La Crosse Boiling Water Reactor
Facility Operating License No. DPR-45
NRC Docket Nos. 50-409 and 72-046

Subject: Response to June 5, 2022 Request for Additional Information for Class 1 Survey Areas

Responses to NRC Questions from June 7, 2022 Call

Figure 1 – Original FSS Scan Lanes and Systematic Soil Sample Locations

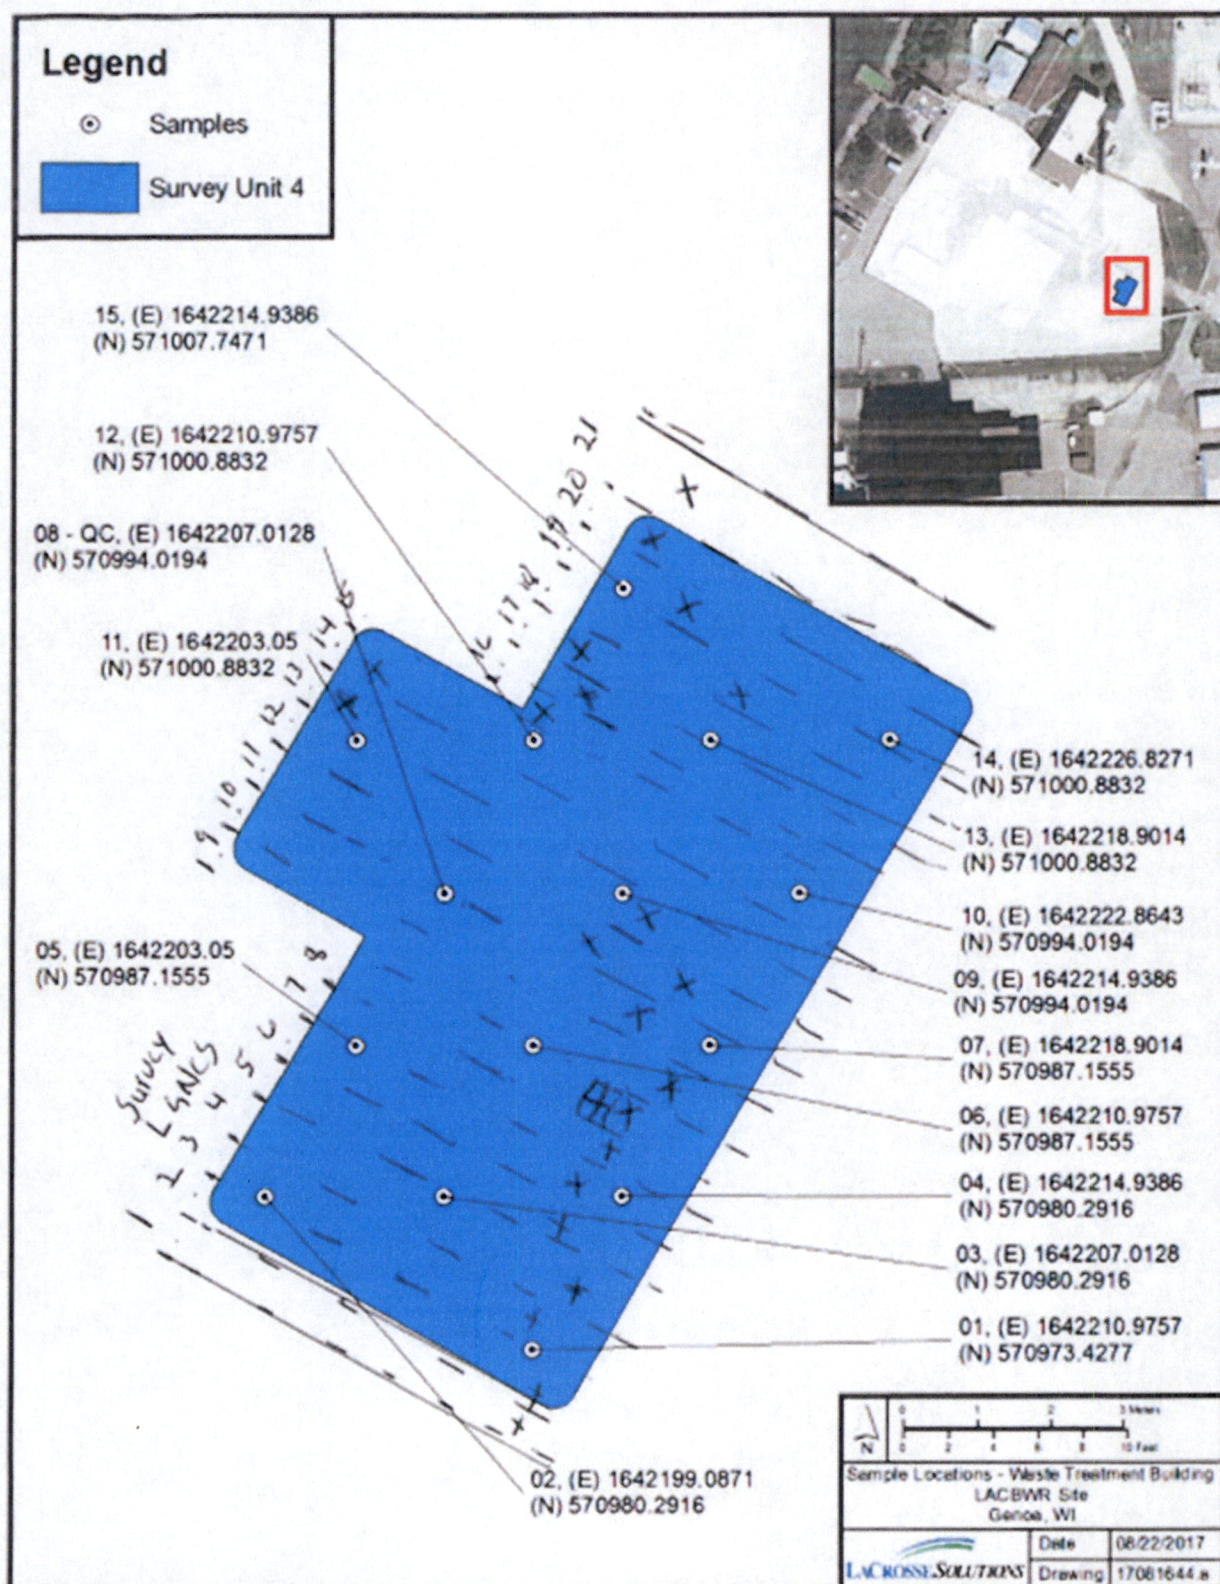
Please provide the original FSS scan data and FSS systematic soil samples (I believe this was collected September 13, 2017, prior to the additional remediation that occurred as a result of inspection). Please include a map of the scan grids overlaid on the systematic locations for the original FSS data.

The original FSS scan lanes are depicted by a solid red line in Figure 3 of these responses and by the hand-drawn lines depicted below in Figure 1. The latched scan readings and reading locations are shown on Figure 3 for each of the 21 scan lanes.

A map, taken from the field logs, of the original scan grids overlaid on the original sample locations map is provided below as Figure 1. Figure 2, also taken from the field logs, depicts the locations of the systematic samples, judgmental samples, the excavation outline, and the composite samples collected at the edges of the excavation.

Figure 3 – WTB Excavation

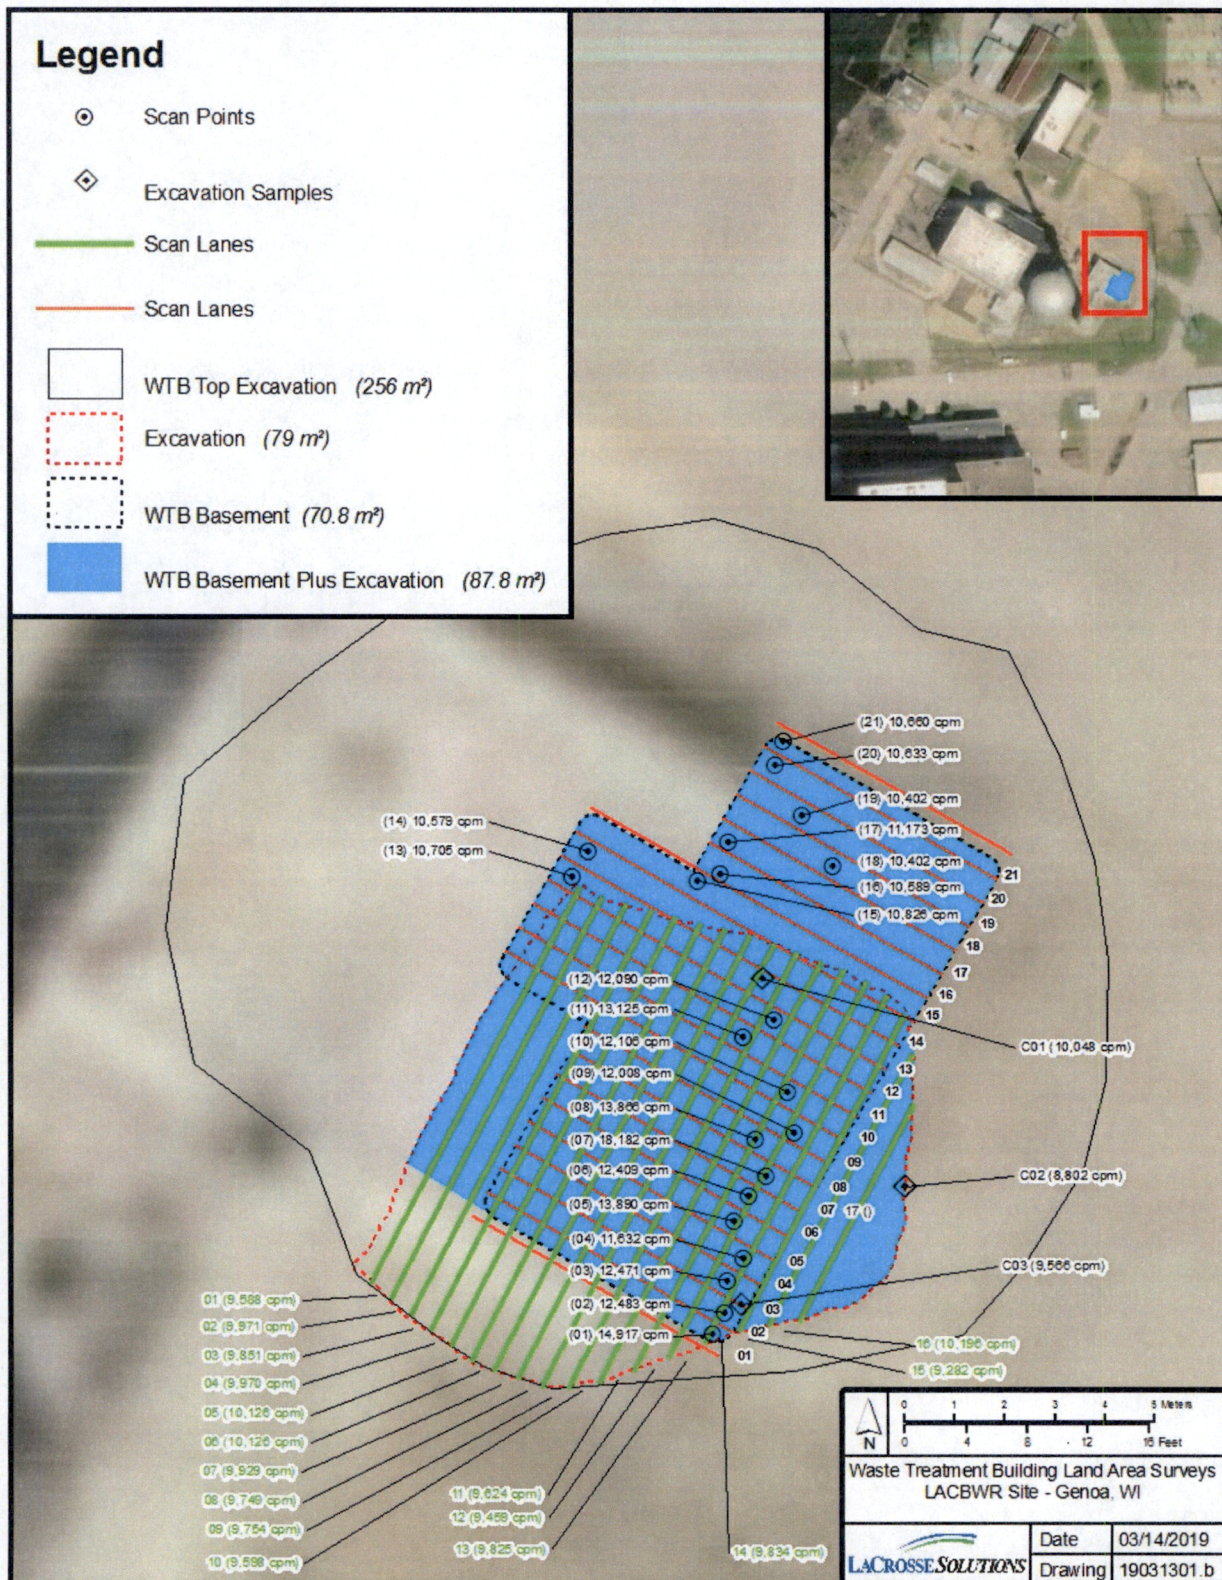
For Figure 16-1, please indicate which portion of the survey unit required additional remediation due to the NRC inspection verification survey. Please confirm that you are not able to recreate the scan grids on Figure 16-1.

Figure 3 below denotes the area (with the red dotted line) that was remediated via additional excavation due to the elevated findings during the NRC inspection verification survey. The map also shows the scan lanes (in solid green) that are labeled as "EX" in the release record. The "EX" scans were collected on September 14, 2017, and covered the entirety of the remediated portion of the excavation. The 21 scan lanes (identified by solid red lines) on the map below are the original scan lanes of the scan performed in the WTB excavation prior to remediation on September 12, 2017.

Figure 5 – Background Area Location

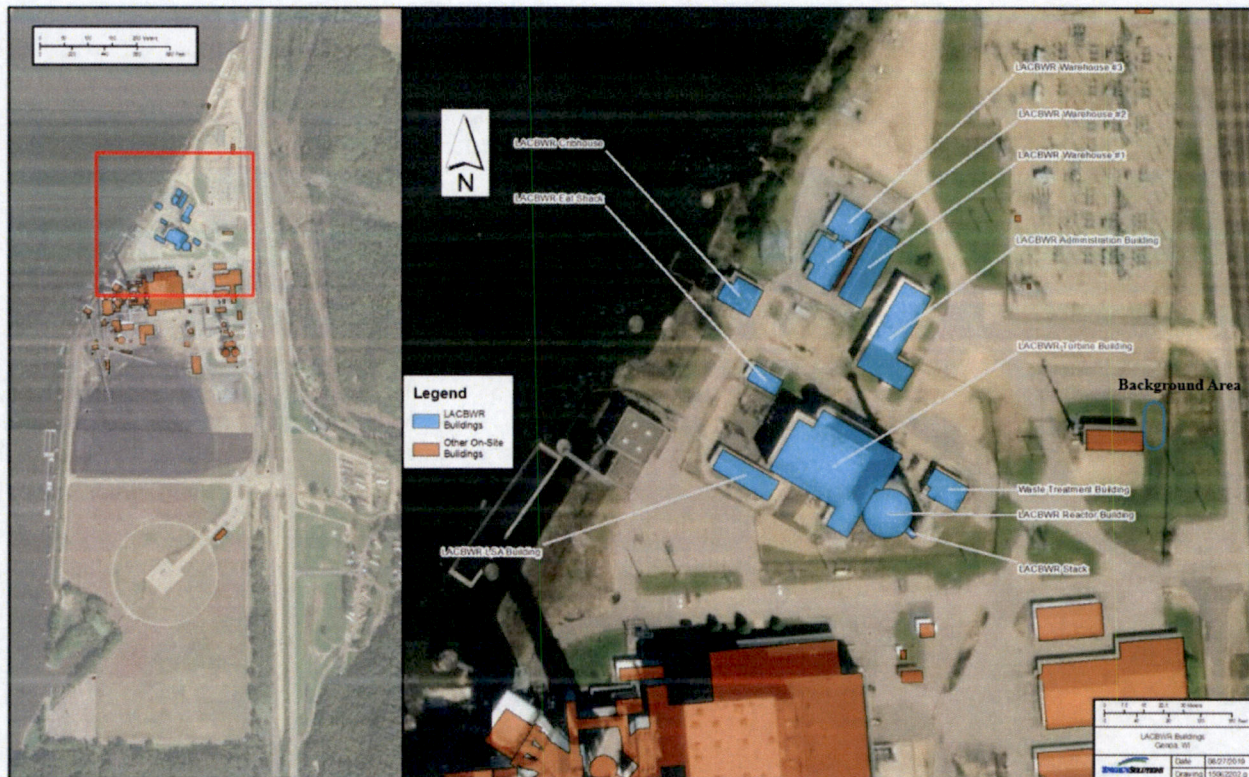
Regarding background for scan data – please describe in more detail why there are two sets of background described in the release record. The first set is the 5,004 cpm - 5,095 cpm (lab background) and the second is the 6,129 cpm - 7,385 cpm (for the SP data points stated to be taken from a nearby field). Please indicate the location of the nearby field. Please state why this is considered more representative of background than the environmental lab value. Please include any procedures used for gathering background values for excavation or land survey areas.

The first set of backgrounds were collected indoors in the portion of the Administration Building utilized as an environmental laboratory. The second set was obtained in a soil and grass area adjacent to the Back-Up Control Center Building, which is the area referred to as a nearby field. Figure 5 below highlights the background area. The values obtained adjacent to the Back-Up Control Center are considered more representative of background due to the material

composition (grass and soil) and the increased exposure to cosmic radiation. The gathering of background values for land areas is not proceduralized and is part of on-the-job training.

Figure 6 – L1-SUB-TDS-A, L1-SUB-TDS-B, L1-SUB-CDR Overview

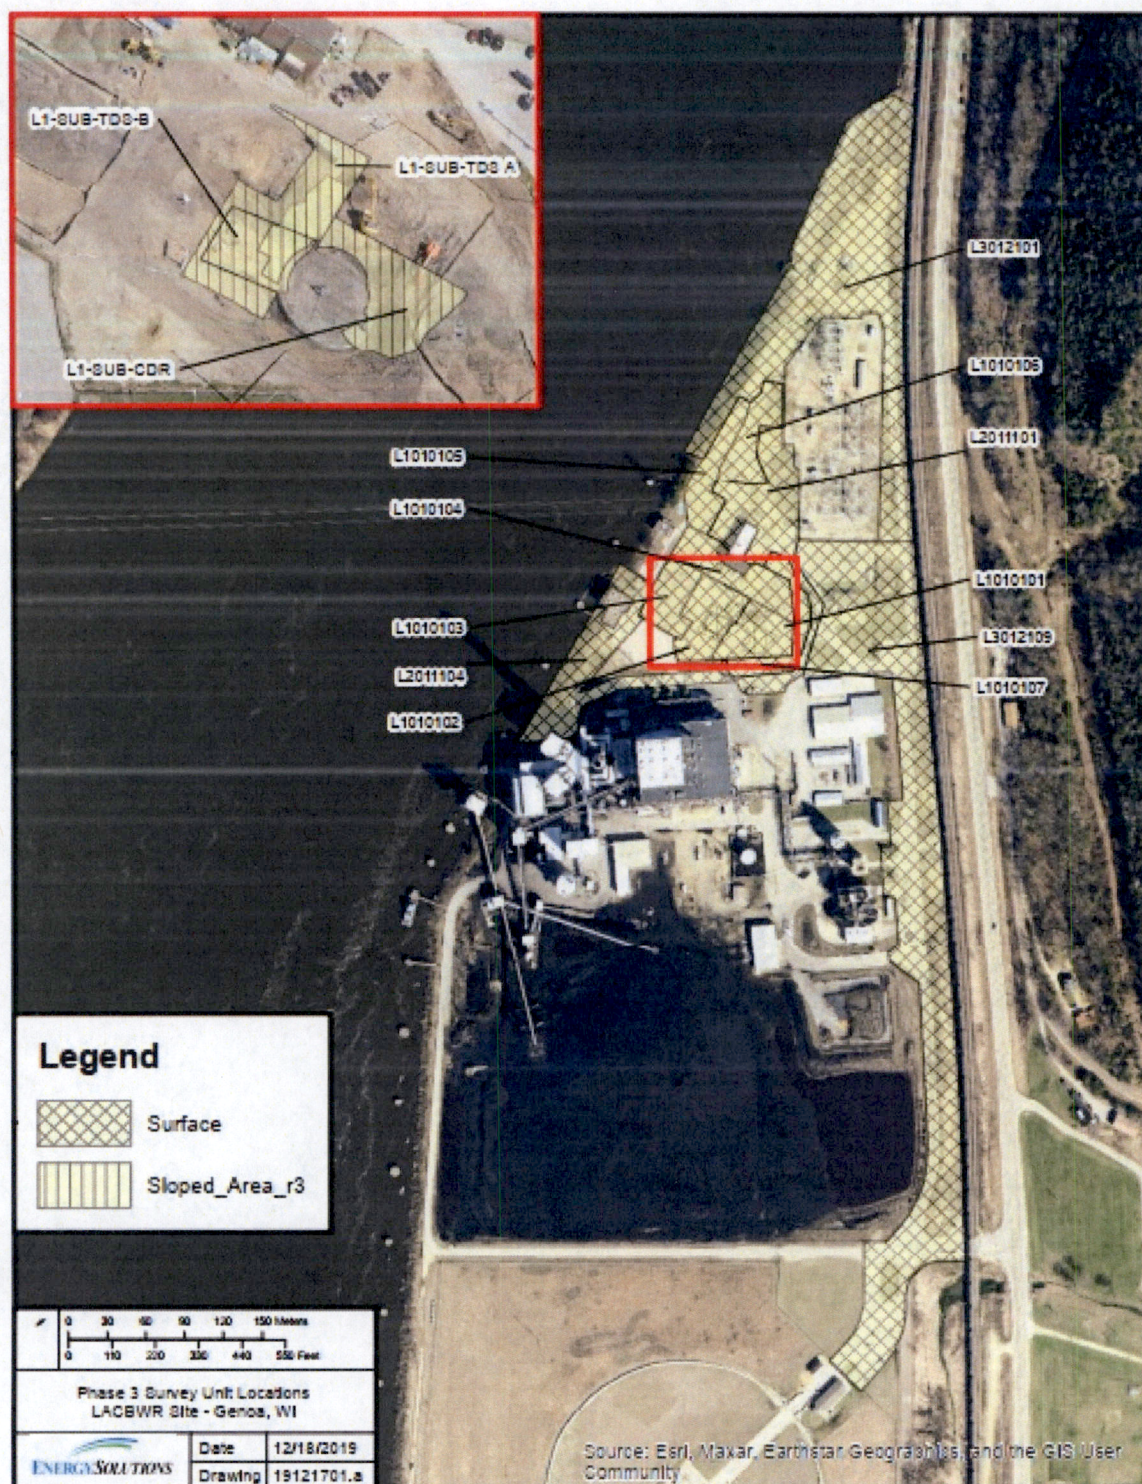
Discuss the boundaries of L1-SUB-CDR, L1-SUB-TDS-A, and L1-SUB-TDS-B and how they potentially overlap. Additionally, discuss the timeline of excavation and fill for these survey units.

Figure 6 below shows L1-SUB-TDS-A, L1-SUB-TDS-B, and L1-SUB-CDR imposed over the site while L1-SUB-TDS-A, L1-SUB-TDS-B were in process. Please note that the dimensions are not 100% accurate and are for illustration purposes only.

The FSS (Geoprobe) of L1-SUB-TDS-B was performed 05/14/2019 through 05/22/2019. L1-SUB-TDS-B also included portions of L1-SUB-CDR as shown in the Figure 6 below.

Portions of L1-SUB-TDS-A were excavated for proper sloping by FSS Technicians as demonstrated by the darker fill material but never reached the extent of where L1-SUB-CDR was excavated to. The FSS of L1-SUB-TDS-A was performed 06/26/2019 through 07/12/2019. As shown in the Figure 7 below, L1-SUB-TDS-A is at different elevations than L1-SUB-TDS-B, the majority of which is higher than L1-SUB-TDS-A.
